PREPARED FOR THE PLAN COMMISSION

Project Address: 405-407 & 431 W Gorham Street, 408-430 W Johnson Street, and 304-318 N Broom Street (District 3 – Alder Verveer)

Application Type: Demolition Permit, Land Use Restriction Agreement, Zoning Text Amendment, Zoning Map Amendment, Conditional Use, and Certified Survey Map Referral

Prepared By: Chris Wells, Planning Division
Report includes comments from other City agencies, as noted.

Image 2: The development's four building 'expressions' (masses)

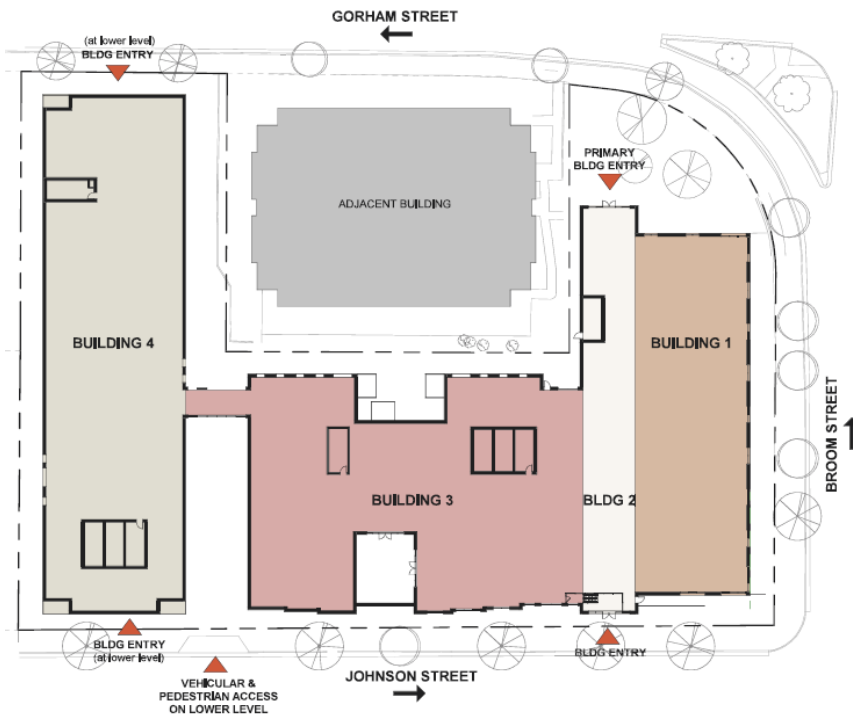
Staff have a few concerns related to the building’s design. The first, which was raised at the Urban Design Commission meeting on November 1, is the lack of ground-floor entrances along the entire 185-foot N Broom Street façade as well as roughly 230 feet of the W Johnson Street frontage. Staff note that the UDC at their aforementioned meeting on November 1, added a condition that an additional connection to the street be incorporated along the W Johnson Street frontage. Staff however still believe that an additional entrance is needed along the N Broom Street frontage noting that, if the Building 1 were a stand-alone building, that a primary entrance oriented to the primary abutting street would be required. (Staff acknowledge that an entrance facing W Gorham could meet this requirement if it were located at or wrapped the north corner).

The second concern is the significant blank wall expanse located on the upper floors of the southwest façade of Building 2 (see Sheet 36 “Elevation Promenade Bldg 3” in the submitted materials). The units on the first eight floors of that façade have multiple windows while the units on Floors 9-14 have none, despite the fact that the upper floors would actually afford a view and be less obscured by the adjacent 12-story Equinox building. When brought up to the applicant, they responded with the following, *“As presented to and approved by UDC, this area on the back side of building 2 is predominately bathrooms on the floors 9-14. This is in the narrow section of the building 2 and the design pushes the living room/kitchen/bedrooms to the Broom- and Gorham-facing facades to maximize views. This section of the building is also effectively screened from view by the Equinox as the building is pulled back from the street frontage and the two buildings are closest together along this property line.”* To this end, Staff note that the northwest façade of Building 2 is set approximately 50 feet further back from W Gorham Street than the same façade of the adjacent 12-story Equinox building meaning the views of the section of blank façade from the public right-of-way will be extremely limited.
